**Re: NOI - DEP File #007-2208
176 Scraggy Neck Road
Map 51, Parcel 1
Bourne, Massachusetts**

**RE: Supplemental Information for Notice of Intent
176 Scraggy Neck Road
Bourne, MA 02532**

**EXISTING CONDITIONS PLAN
 IN BOURNE, MA**
 Prepared For:
**STEPHEN & MARYBETH BISSON
 TRUSTEES OF THE LONG
 POINT TRUST**
 #176 SCRAGGY NECK ROAD
 MAP 51 PARCEL 1 (LOT 2)

PROPOSED SITE PLAN
IN BOURNE, MA
Prepared For:
STEPHEN & MARYBETH BISSON
TRUSTEES OF THE LONG POINT TRUST
#176 SCRAGGY NECK ROAD
MAP 51 PARCEL 1 (LOT 2)

Restoration/Mitigation Planting Plan

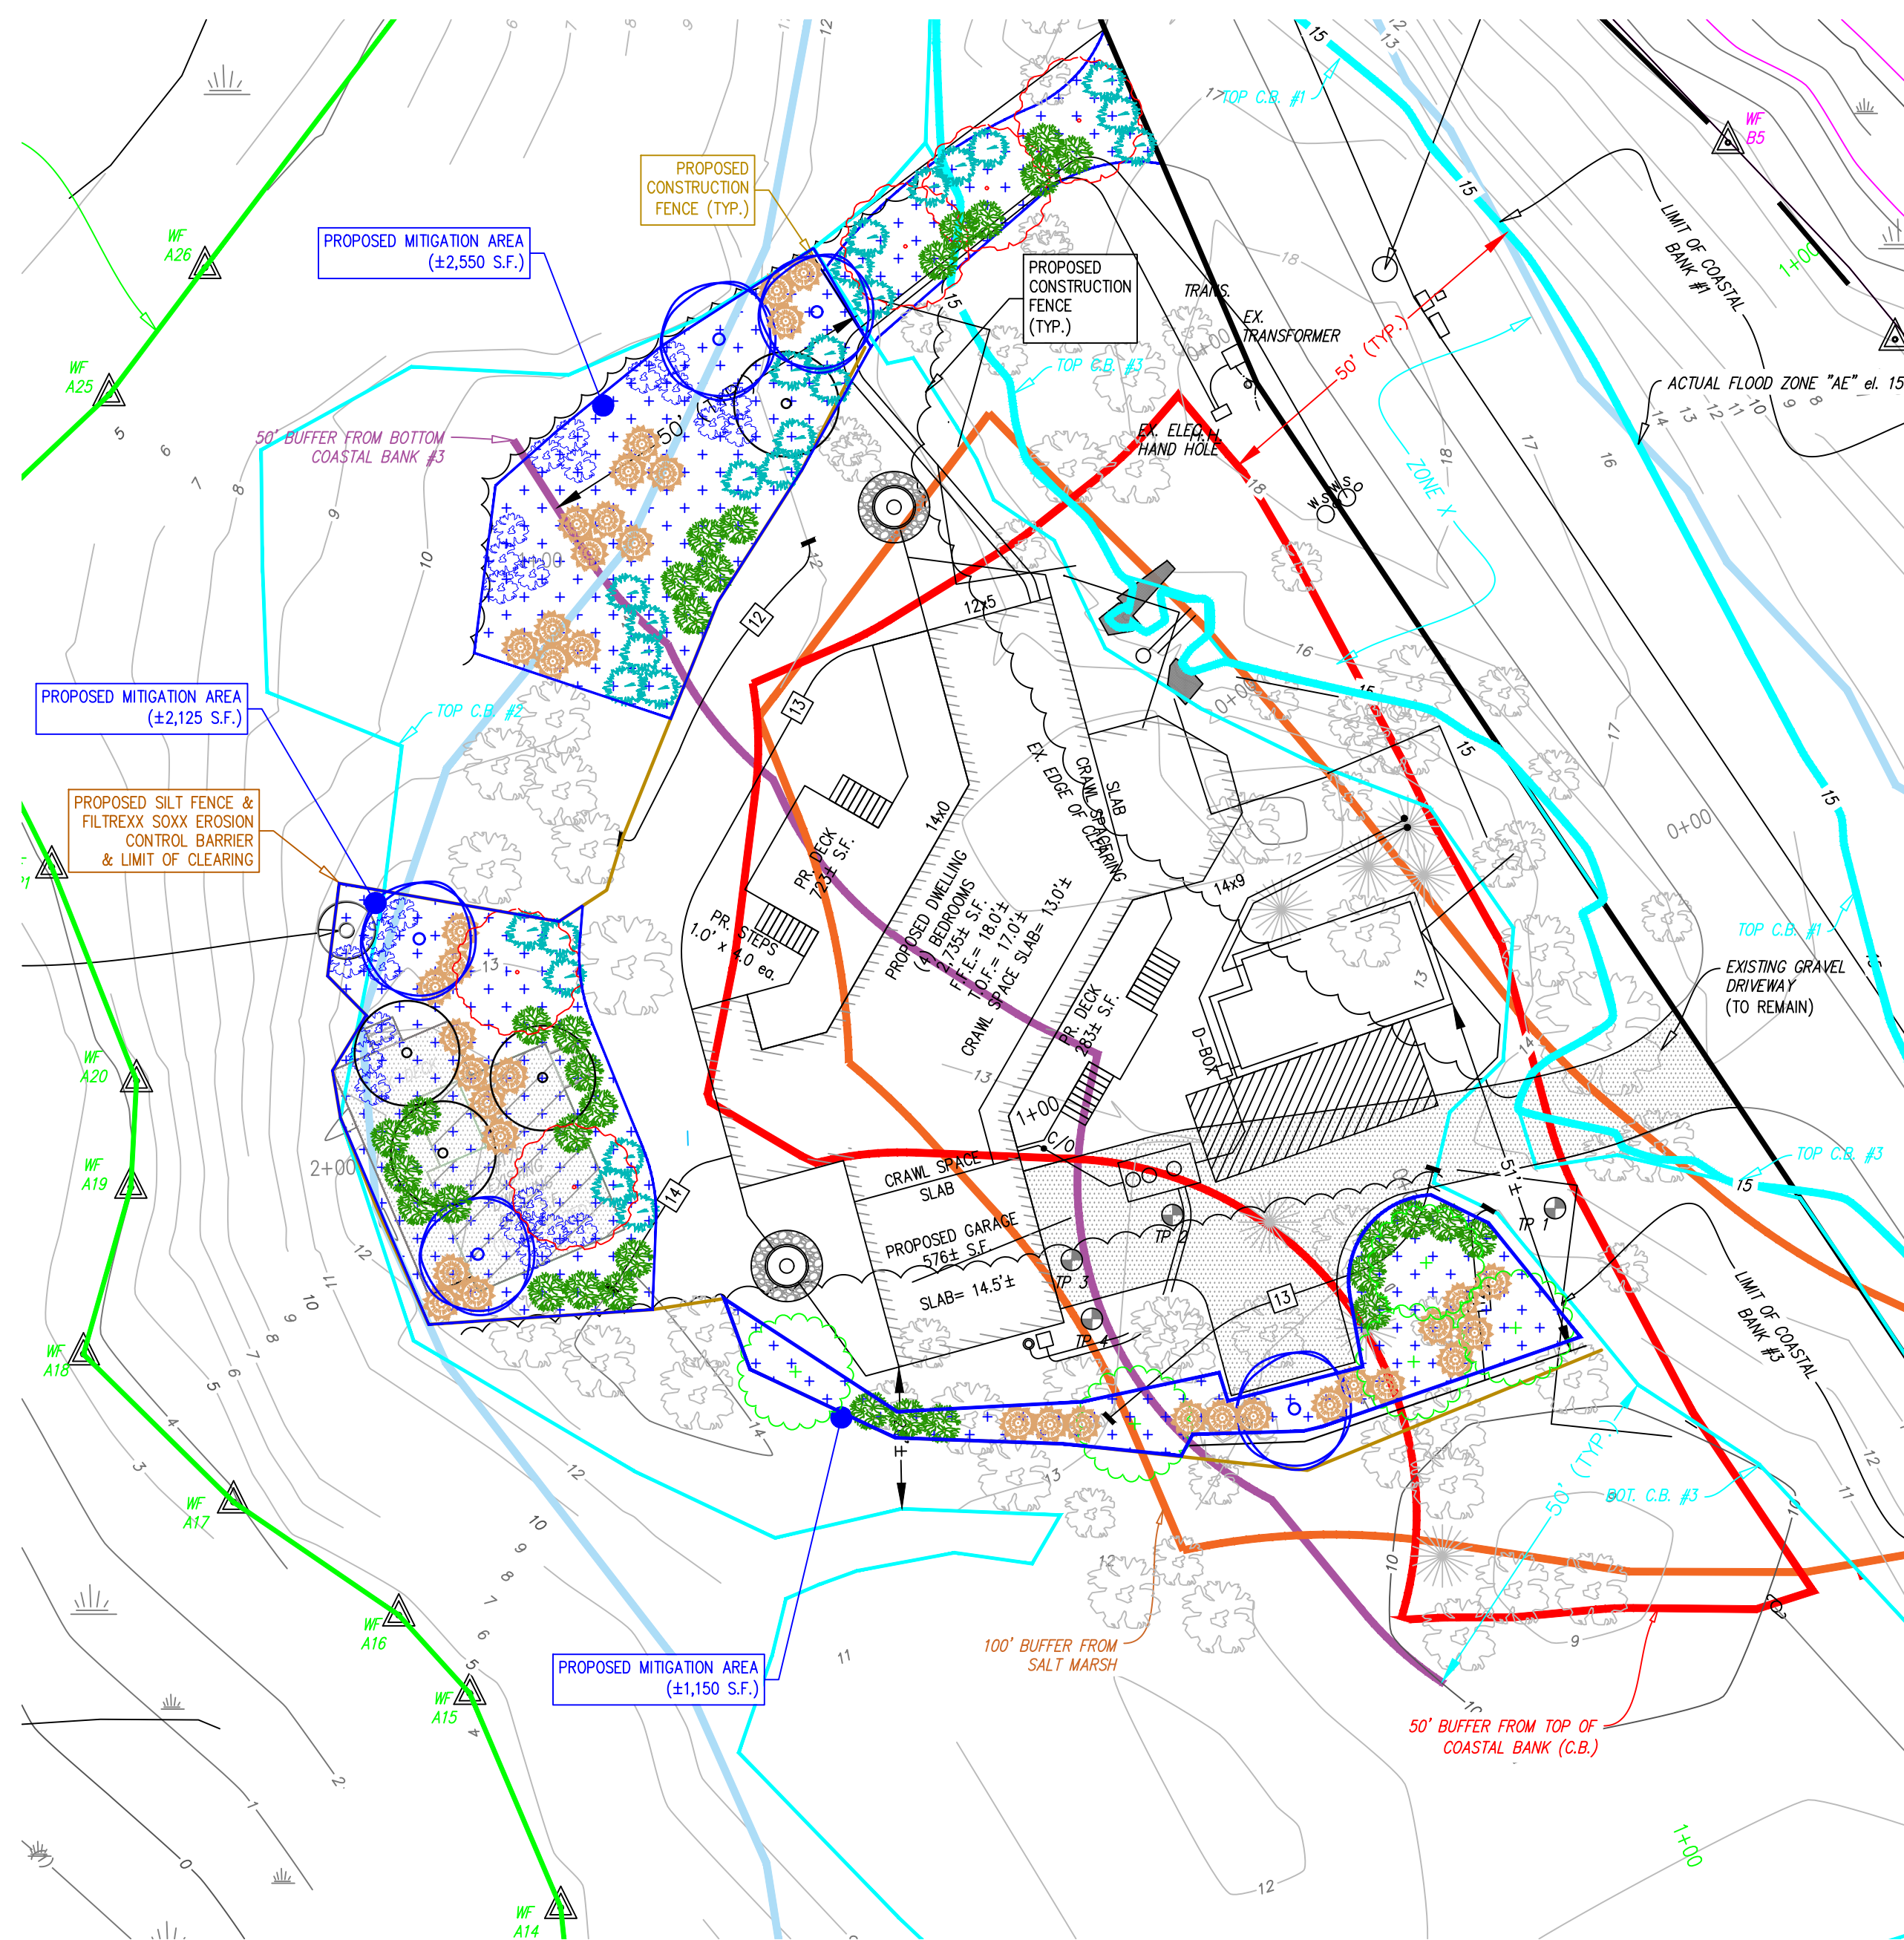
The revised *Restoration/Revegetation Plan*, prepared by LEC, dated September 28, 2022, accompanies this submission. The restoration/revegetation planting area totals 5,825± square feet, including existing lawn/driveway areas north of the proposed dwelling within LSCSF and partially on the Coastal Bank and existing house footprint (4,675 ± square feet of restoration). The 1,150± square feet of regraded area south of the dwelling will also be revegetated. The restoration/mitigation planting area consist of a diverse mix of trees, shrubs, and groundcover to enhance species diversity, vegetative cover, and wildlife habitat. Proposed species include eastern red cedar, black oak, eastern white pine, tupelo, highbush blueberry, bayberry, beach plum, and arrowwood. A total of nineteen (19) trees are proposed and one hundred twenty-four (124) shrubs. The southerly restoration/revegetation planting area includes eastern white pine saplings to additionally function for vegetative screening purposes to the southerly abutter. A New England Conservation/Wildlife Mix and Coastal Salt Tolerant Mix are proposed throughout. All planting areas will be monitored for three years to ensure successful establishment. Annual monitoring reports will be submitted to the Commission documenting vegetative health and any recommendations.

The proposed plantings will enhance, stabilize, and restore conditions within the 100-foot Buffer Zone, LSCSF, and on the Coastal Bank (266± square feet). The revegetation measures will serve to create a continuous and expanded vegetated buffer upgradient of the westerly, primary Coastal Bank (#2) and downgradient Salt Marsh system. The vegetated buffer will serve to attenuate runoff on slopes within the Limit of Work that are less than 10:1. The proposed erosion and sedimentation controls installed along the Limit of Work will protect the downgradient Coastal Bank and Salt Marsh during construction. Post-construction, runoff from the dwelling will be directed to drywells and subsurface infiltration system installed within well-drained soils and will not be directed downgradient towards the Coastal Bank.

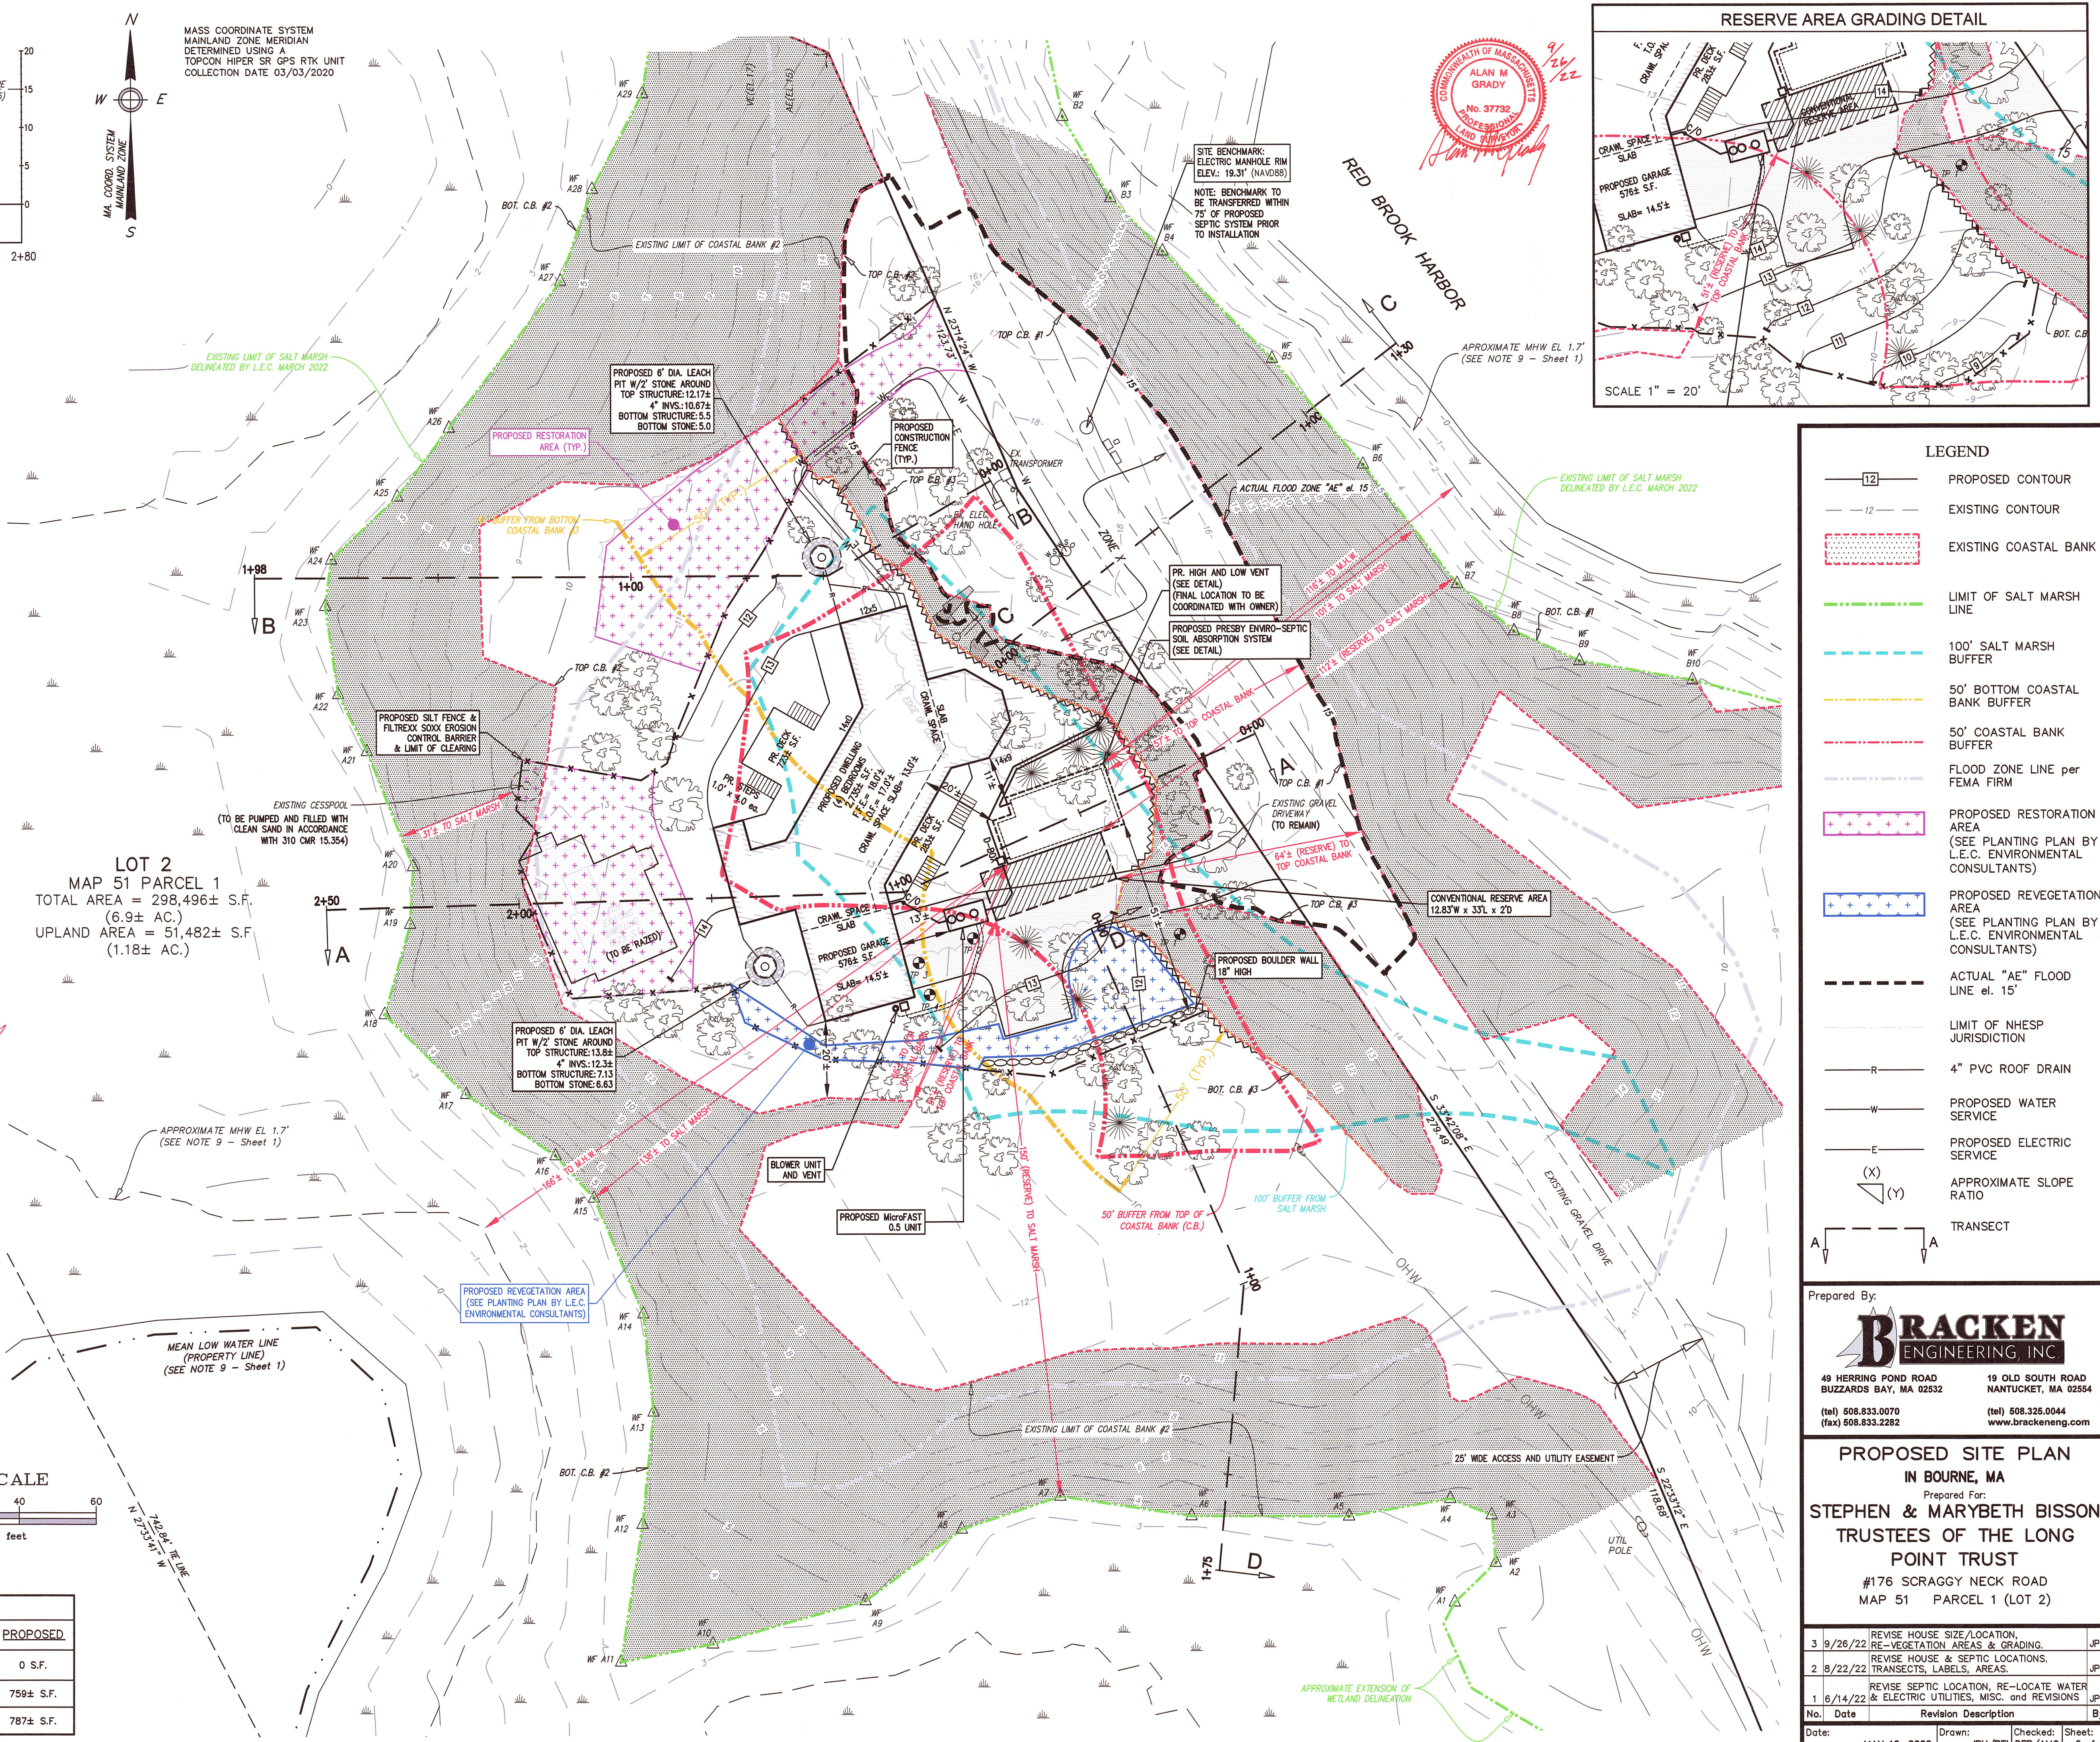
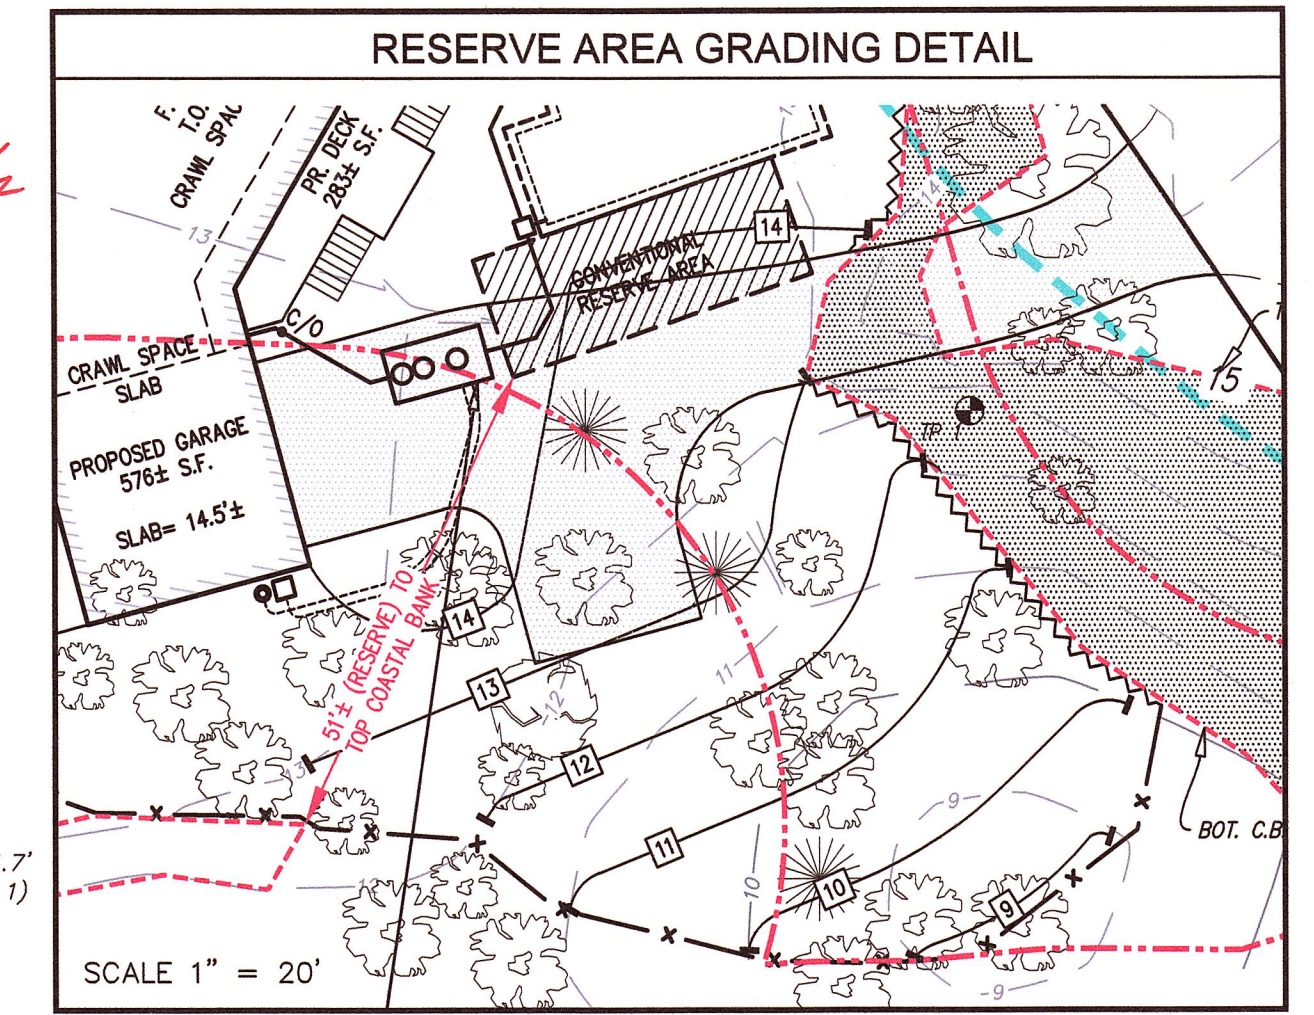
- 1) The proposed dwelling footprint has been further reduced in size. Cumulatively, the dwelling has been reduced by 399± square feet in comparison to the originally submitted site plans, dated May 16, 2022.
- 2) The proposed dwelling footprint has been rotated/shifted to further reduce the structural area within the 50-foot Buffer Zone and increase the separation of the closest top of Coastal Bank to proposed garage (on slab) to 20 feet in comparison to 7 feet on the original site plans.
- 3) The proposed Limit of Work has been reduced south of the driveway and garage to preserve more trees within the Buffer Zone to the Coastal Bank. An 18 inch boulder wall is now proposed immediately south of the driveway.
- 4) Proposed fill has been reduced to 172± cubic yards from the 326± cubic yards associated with the prior submittal.

No.	Date	Revision Description	By
3	9/26/22	REVISE HOUSE SIZE, LOCATION, RE-VEGETATION AREAS & GRADING.	JPH
2	8/22/22	REVISE HOUSE & SEPTIC LOCATIONS, TRANSECTS, LABELS, AREAS.	JPH
1	6/14/22	REVISE SEPTIC LOCATION, RE-LOCATE WATER & ELECTRIC UTILITIES, MISC. AND REVISIONS	JPH
